VILLAGE OF SUSSEX
SUSSEX, WISCONSIN

Minutes of the Architectural Review Board (ARB) meeting held on December 2, 2020.

III. Consideration and possible action on the site plan, architectural plan and lighting plan, for Bevco Engineering (W222N5739 Miller Way).

**BEVCO ADDITION
W222N5739 MILLER WAY
SUSSEX, WISCONSIN**

Drawn By: MF
Date: 9-24-20
Scale: 1" = 30'-0"
Job Number:
Sheet Name: **SITE PLAN**
Sheet Number: **A1.1**
SHEET OF TOTAL SHEETS

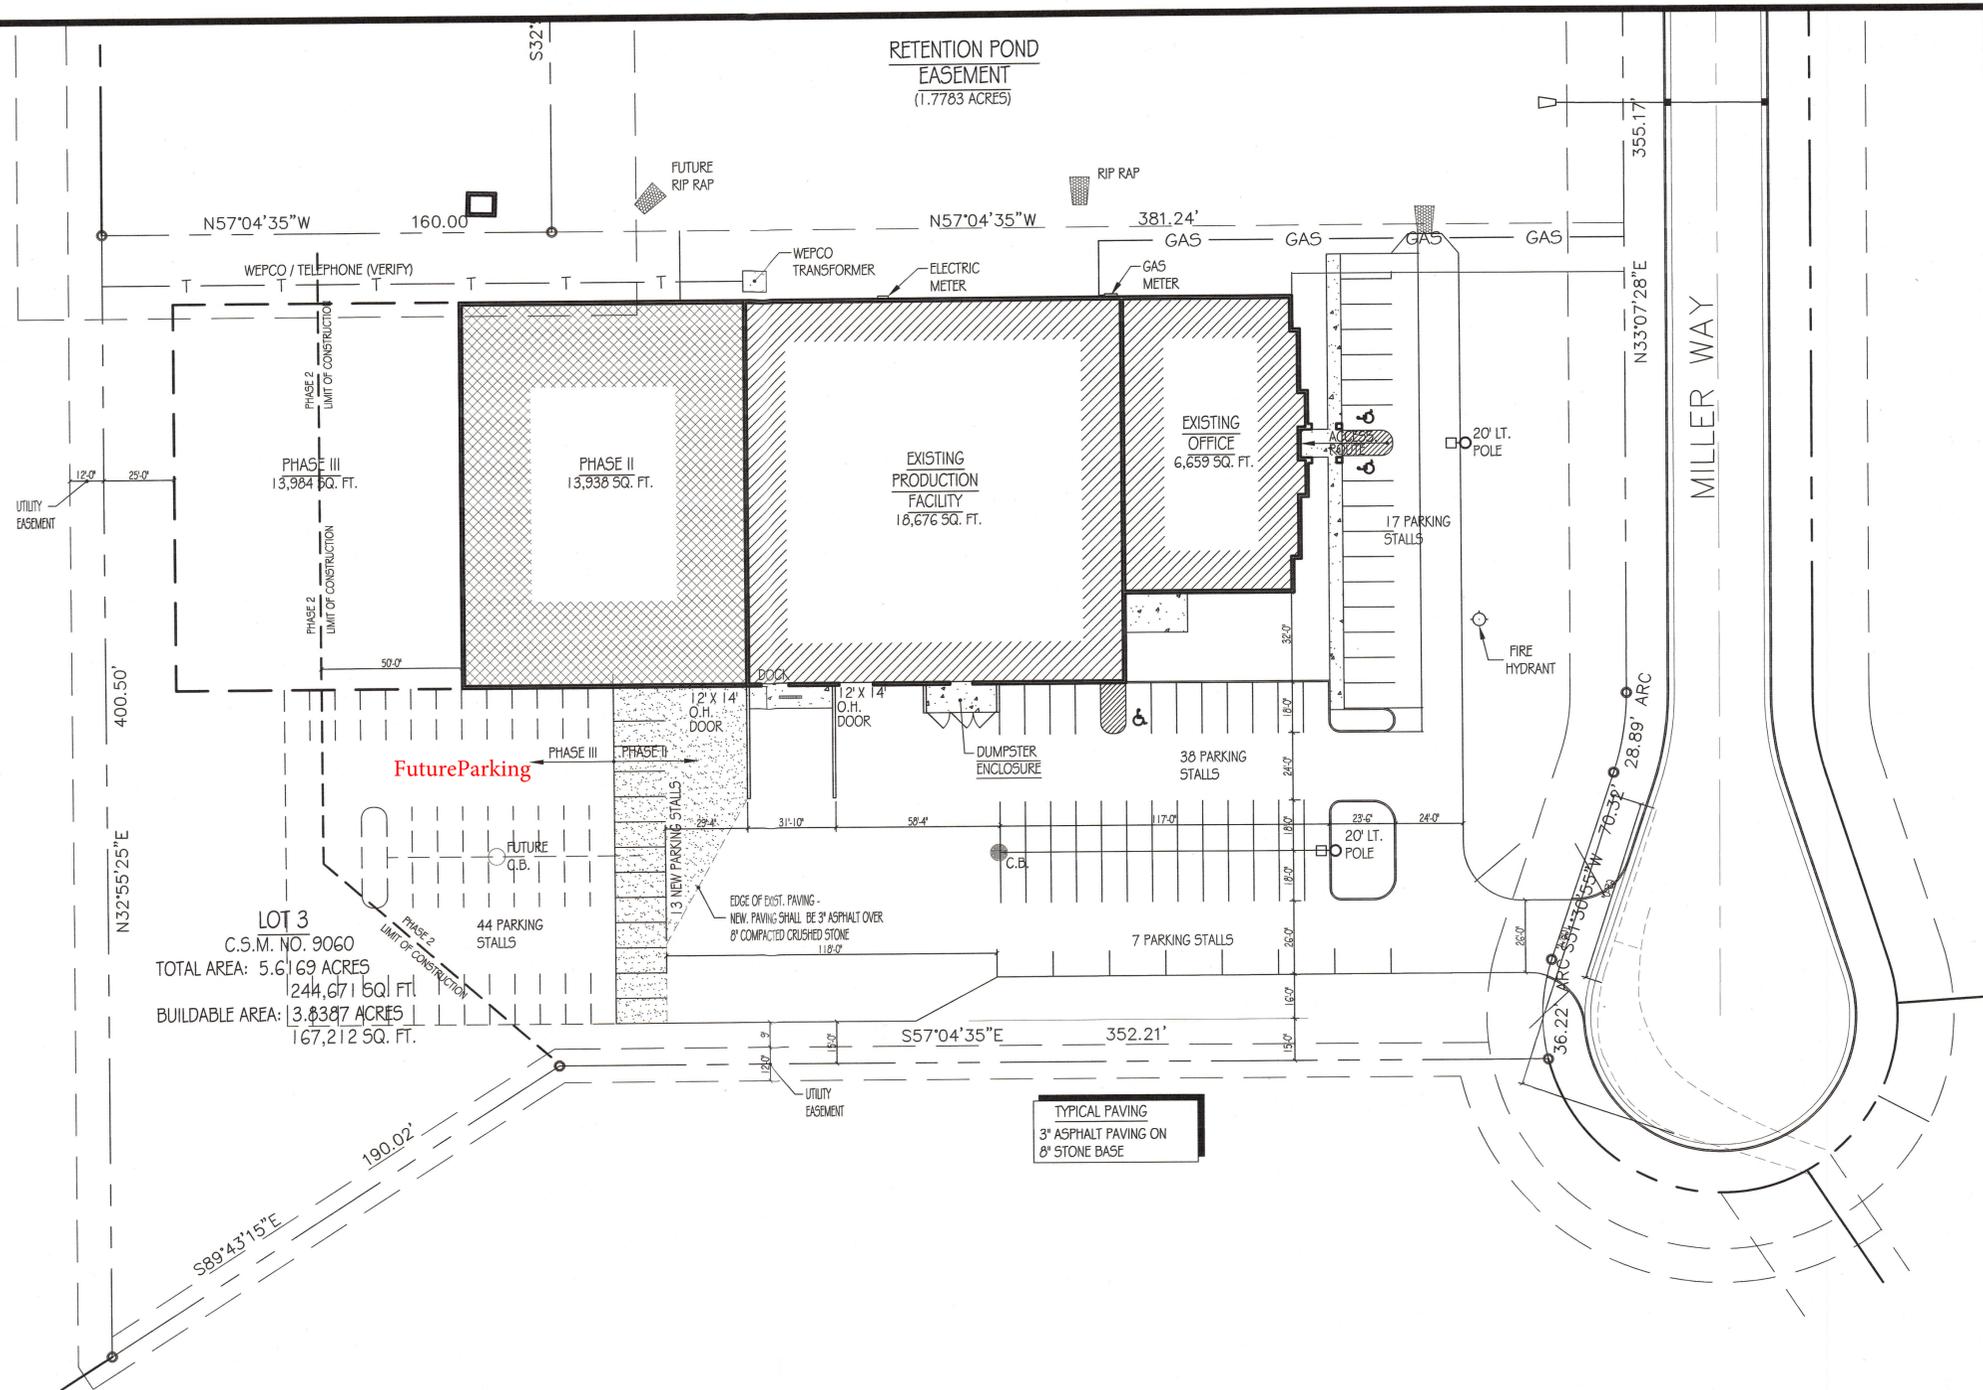
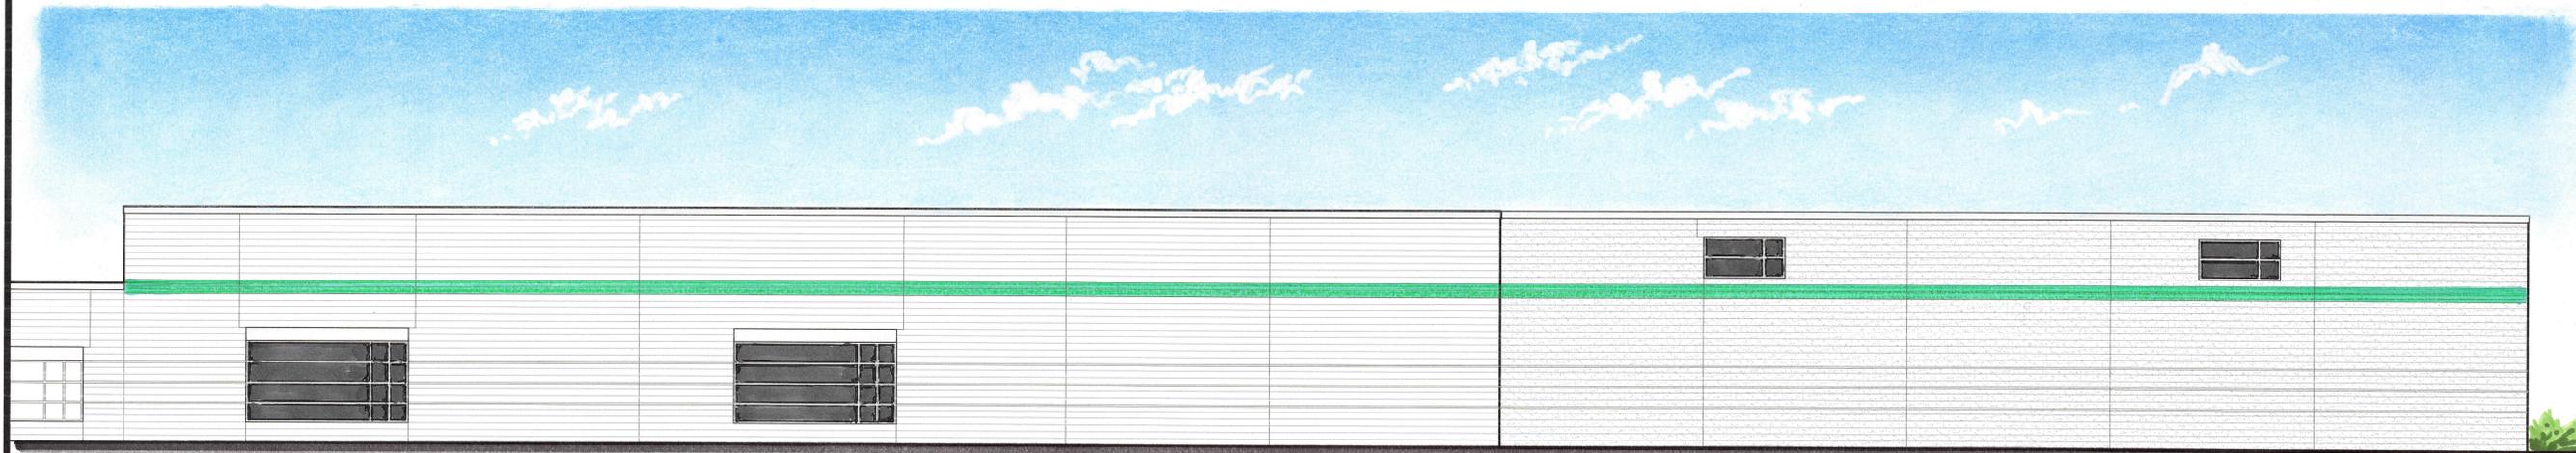
Site – it was consensus of the ARB to approve the site plan.

- Adding 13 parking stalls
- Addition meets all required setbacks

Drawn By
 MIF
 Date
 9-24-20
 Scale
 1/8" = 1'-0"
 Job Number
 Sheet Name
EXTERIOR ELEVATIONS
 Sheet Number

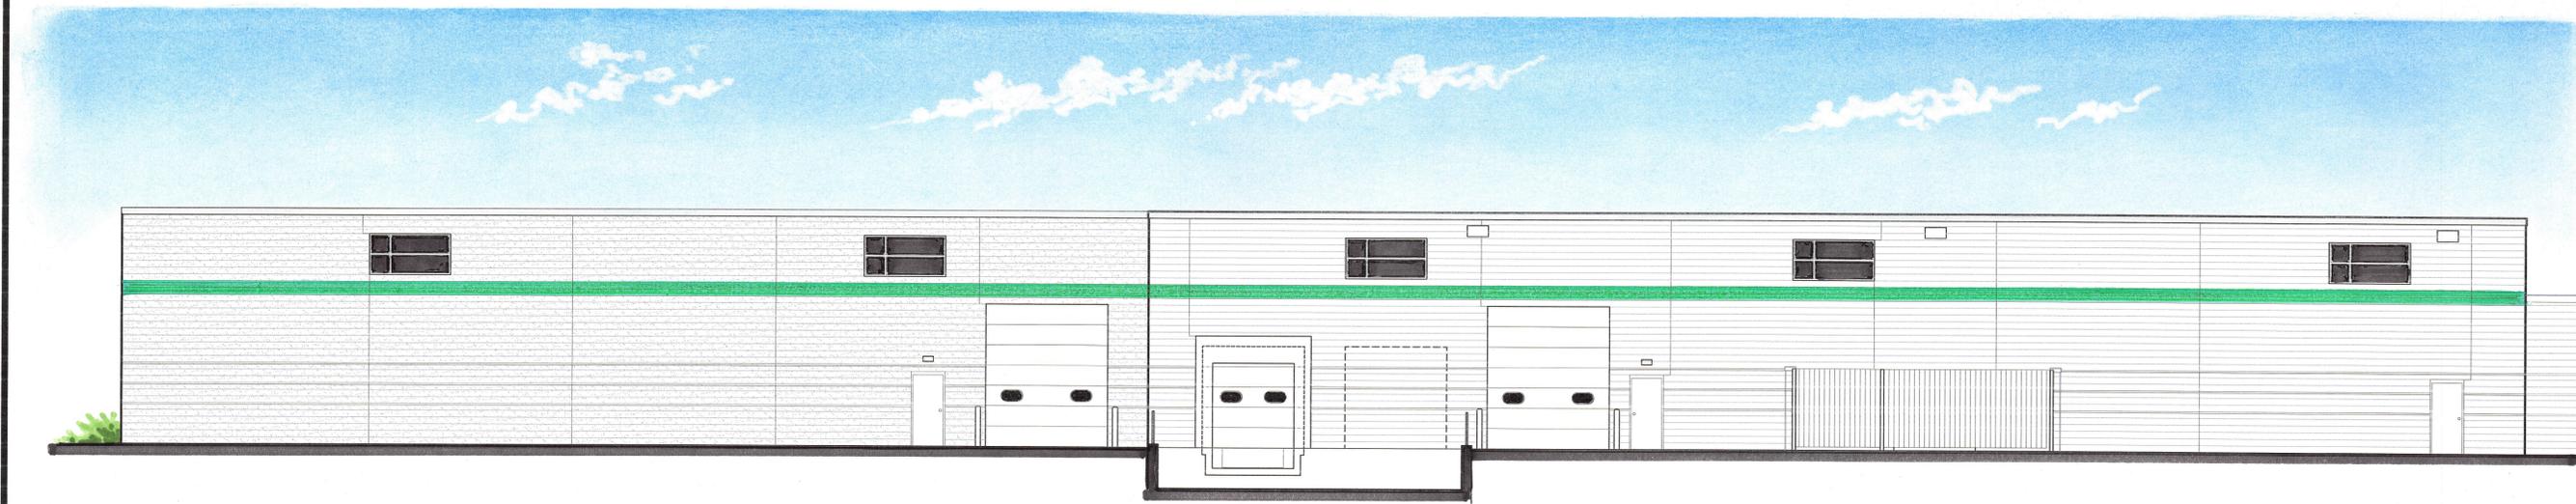
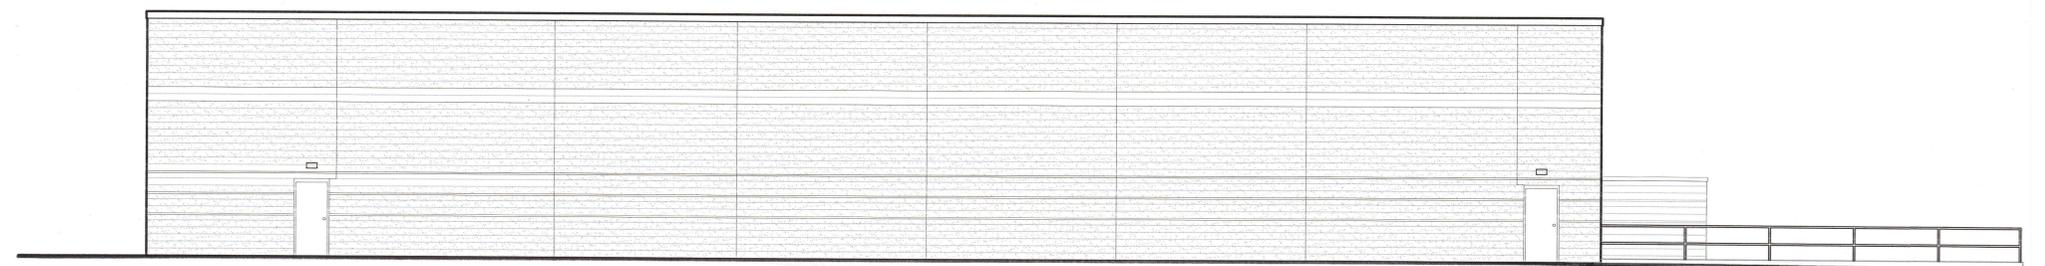
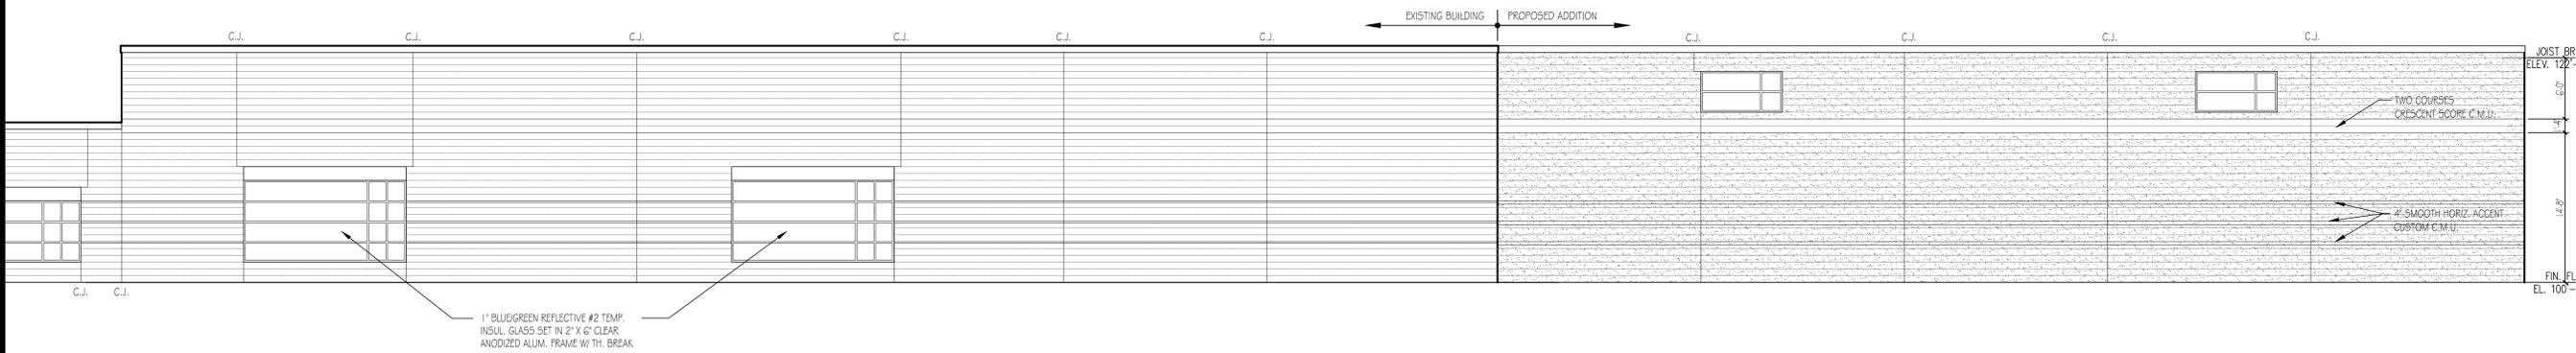
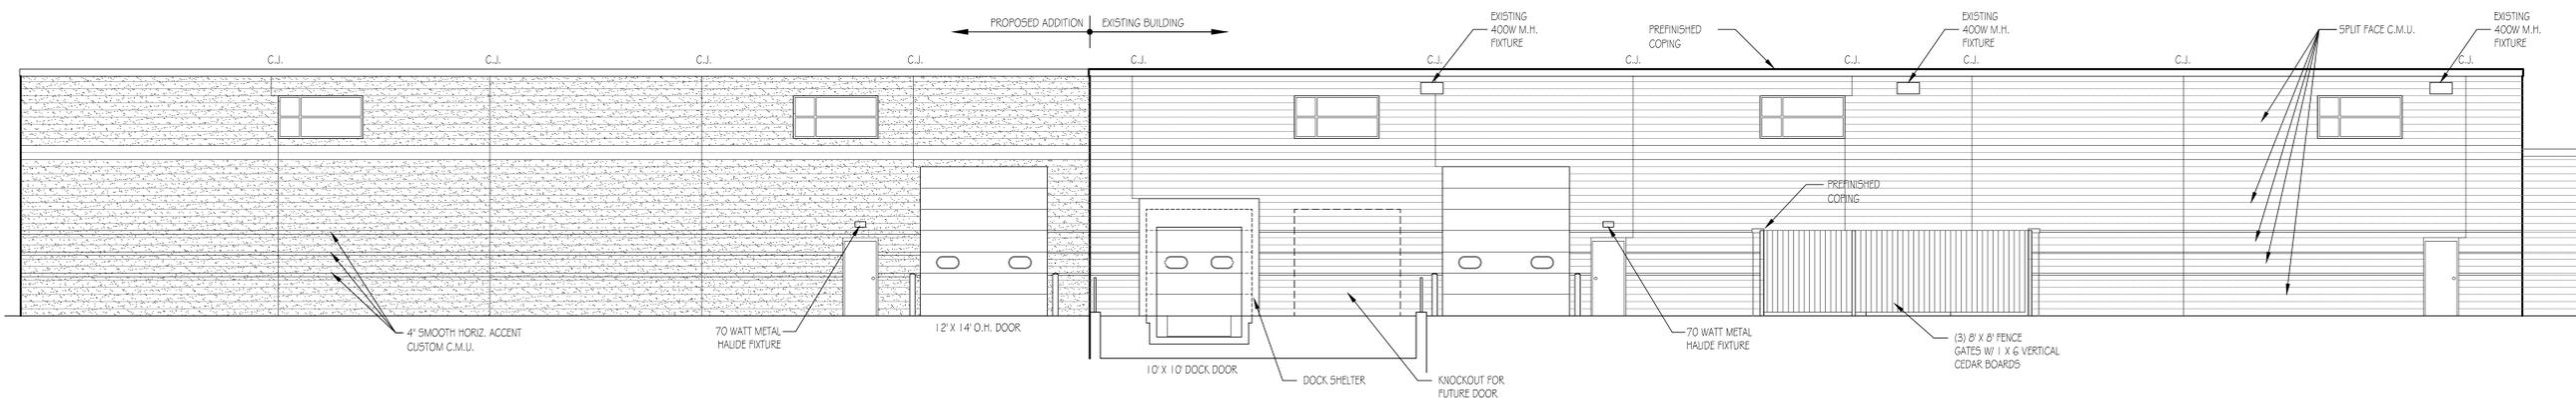
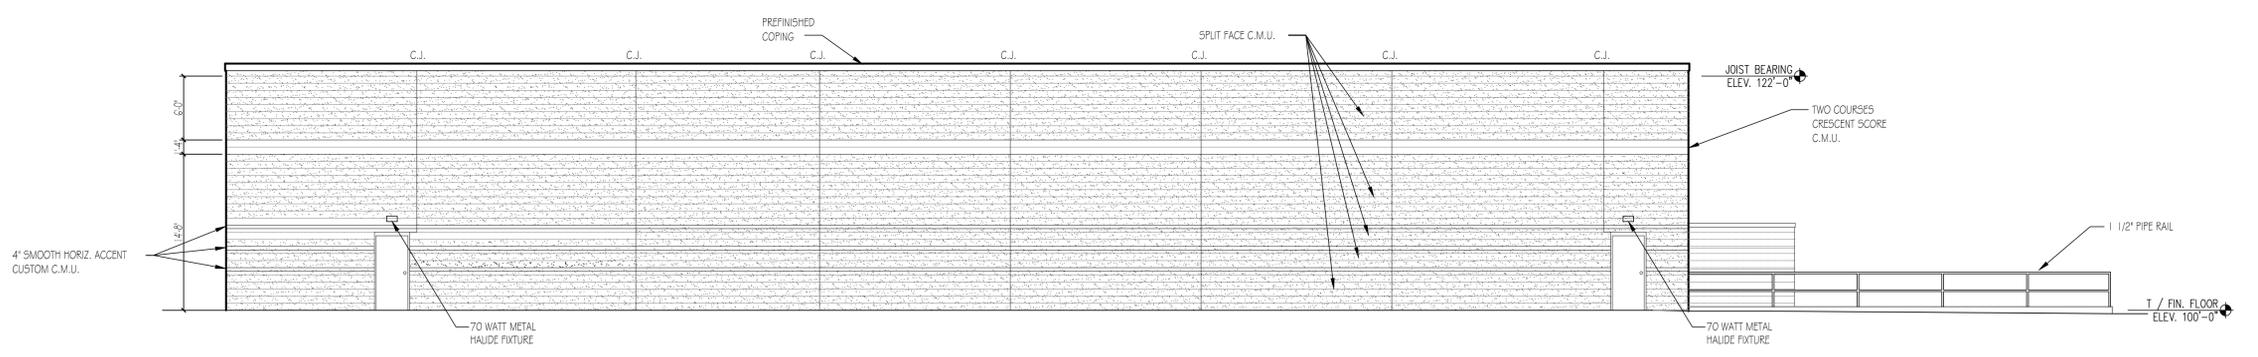
Architecture – Mr. Nell explained the material for the lower banding on the building is no longer available but they have found a solution to tie it in with the existing and will not be noticed. It was the consensus of the ARB the architecture plan meets the requirements.

- Building meets height requirements
- Material to be used meets the Design Standards

Plan View
Scale - 1" = 20ft

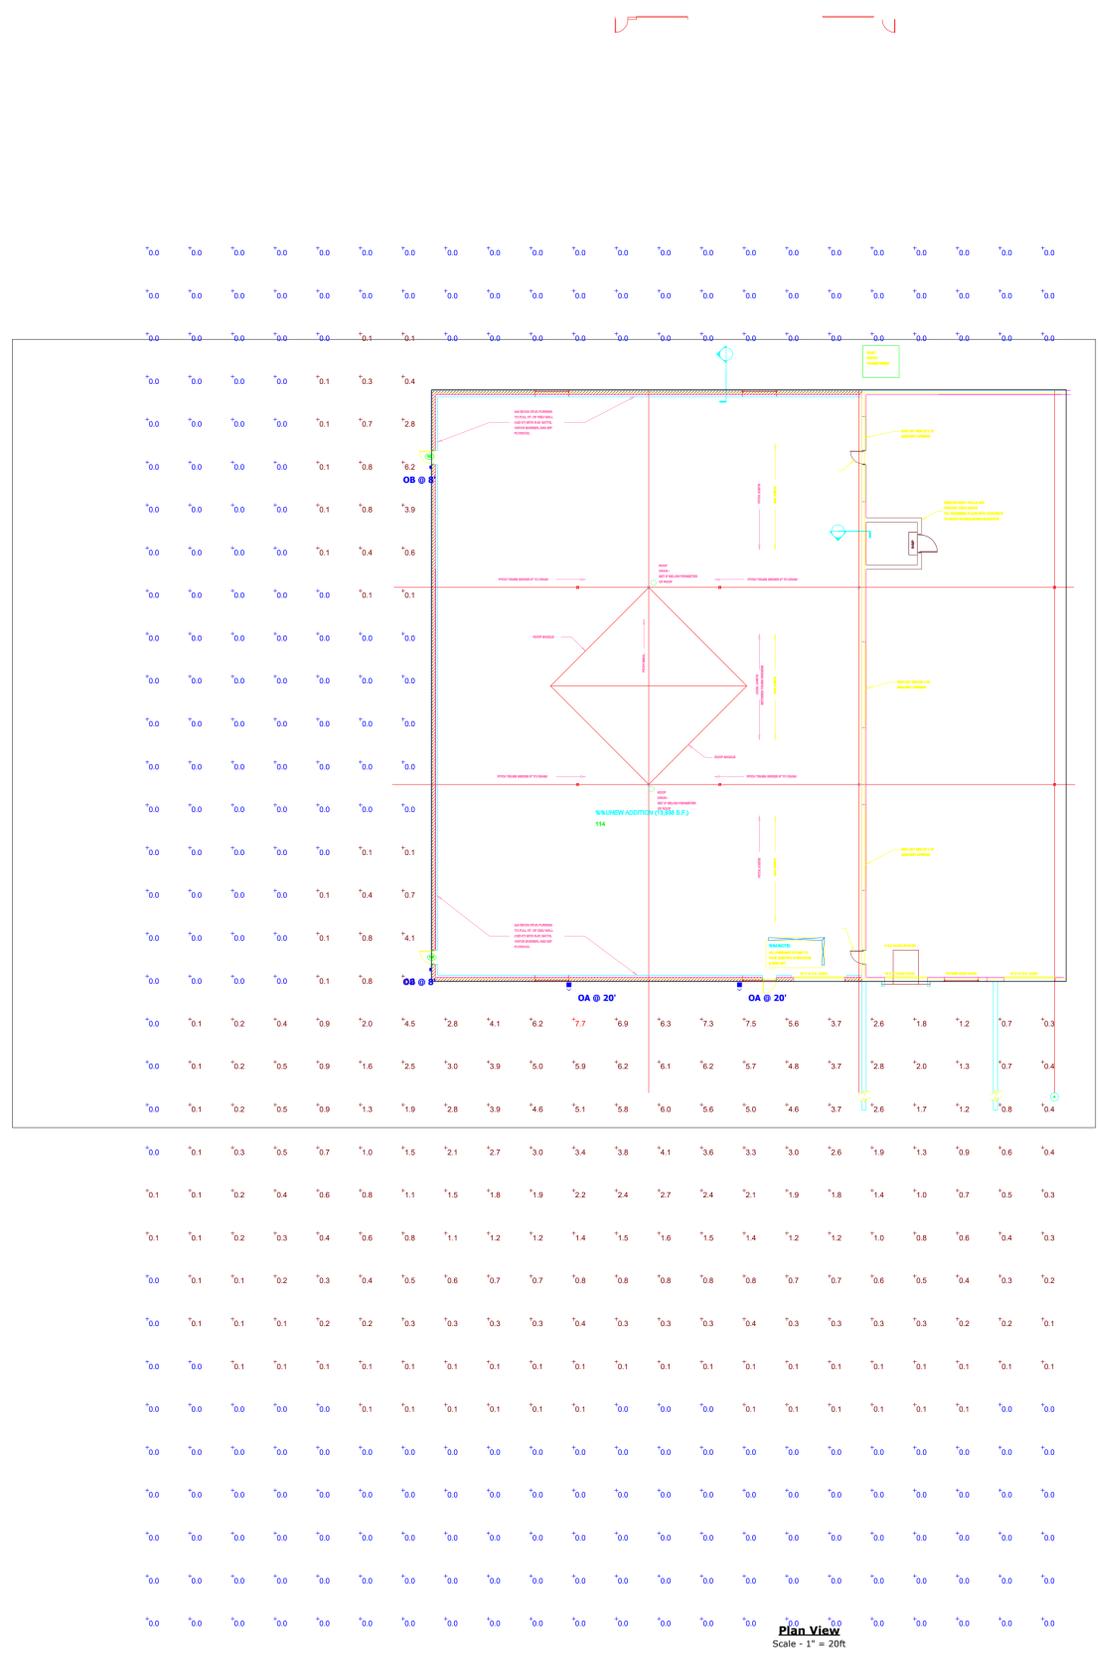
Lighting – Mr. Nell stated the wall packs on the existing building and new building will all be replaced using the same wall pack to match and replaced with LED lighting. It was the consensus of the ARB the lighting plan meets the requirements.

- Lighting plan meets requirements
- Building wall lights should match or blend with existing wall lights
